**RE: CENTRAL PARK, BROADWAY – CONCEPT PLAN MP06_0171 (MOD 10) AND
BLOCK 4N STATE SIGNIFICANT DEVELOPMENT APPLICATION FOR A MIXED USE
BUILDING (SSD 14_6673)**

As requested, please find herein GTA Consultants' response to City of Sydney Council's comments in relation to the proposed drop-off spaces on Central Park Avenue proposed as part of the above proposed developments.

Attachment One

Swept Path Diagrams

CENTRAL PARK
SWEPT PATH ASSESSMENT
9.5m WASTE TRUCK AND B99 CAR

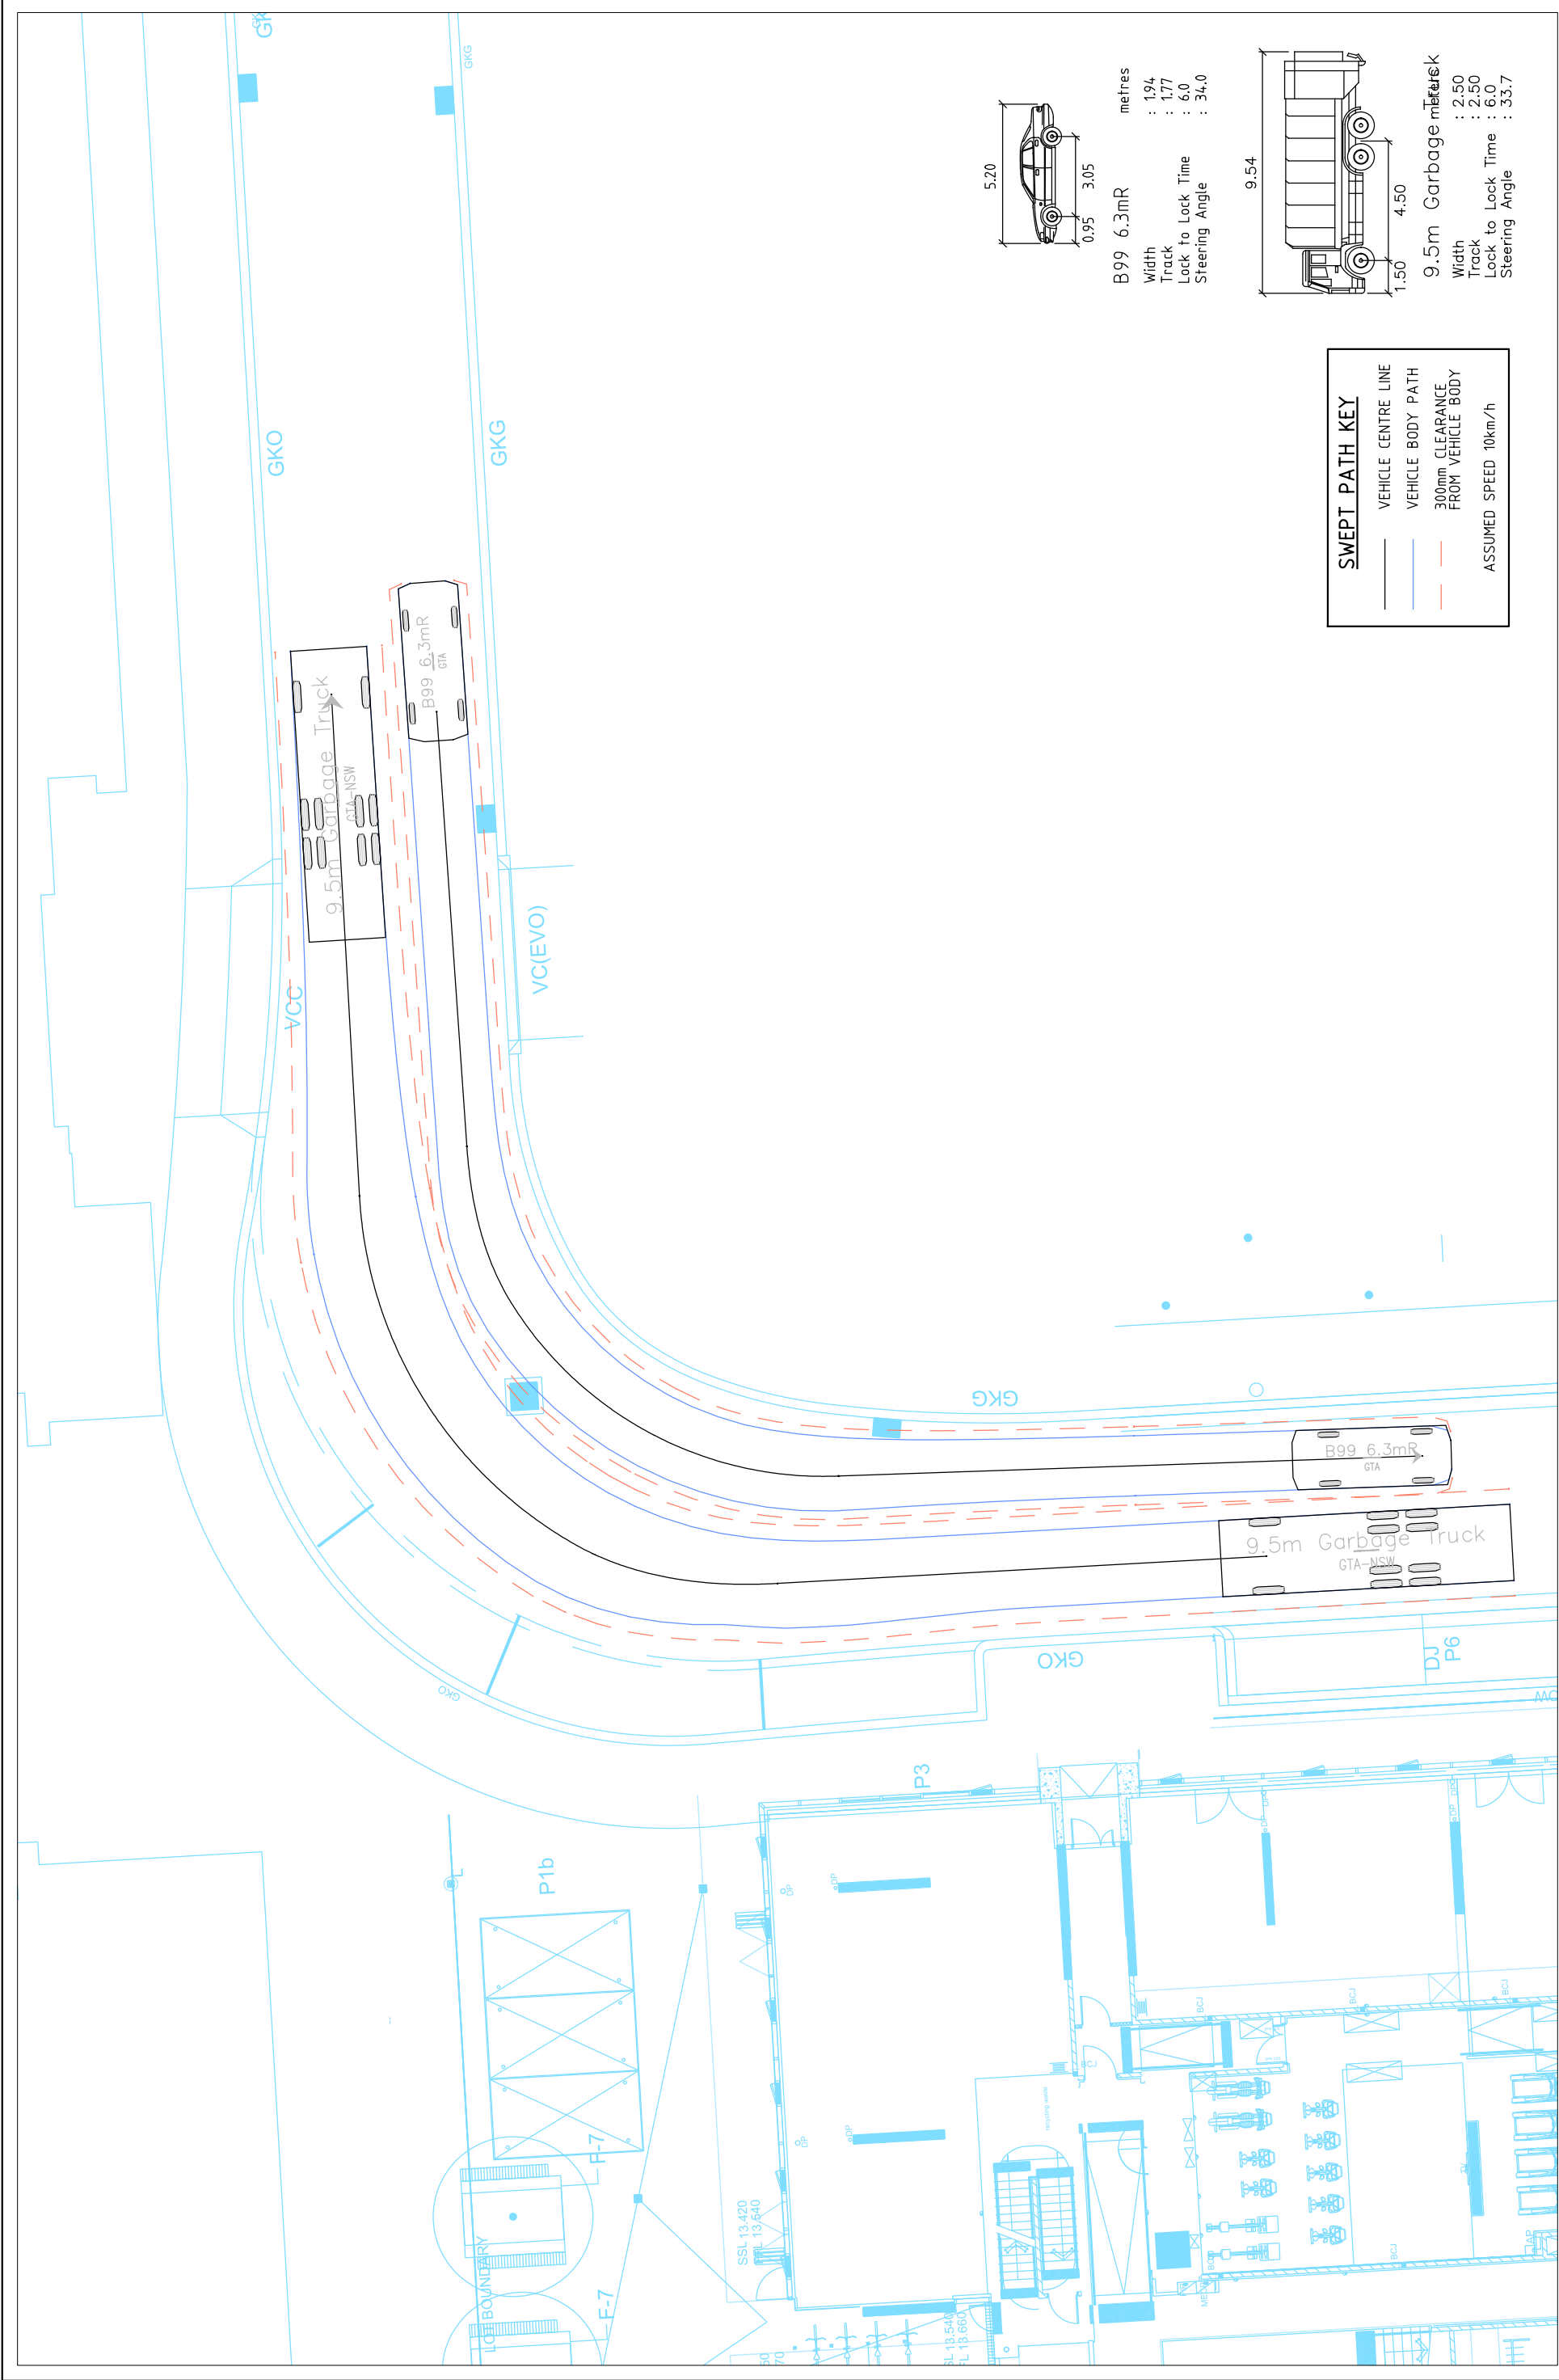
- swept path analysis at Central Park Avenue to ensure garbage trucks can adequately travel along Central Park Avenue
- ability of pick-up/drop off spaces to safely accommodate the parking of buses
- provision of adequate footway widths
- justification for the '5 minute' pick-up/drop off restriction, and
- justification for providing only three pick-up/drop off spaces, to be shared between the hotel and childcare facility.

As requested by Council, GTA Consultants has conducted a swept path analysis of Council's 9.5m long waste collection vehicle travelling around the bend along Central Park Avenue. The analysis assumes that the waste collection vehicle travels around the bend against another vehicle (B99 5.2m long vehicle) in the opposite direction. The analysis also assumes that the proposed drop-off spaces around the bend are all occupied by parked vehicles.

The swept path diagram shows that a 9.5m long waste collection vehicle could travel around the bend without overhanging into the proposed drop off spaces or crossing on to the wrong side of the road.

Therefore, this is satisfactory.
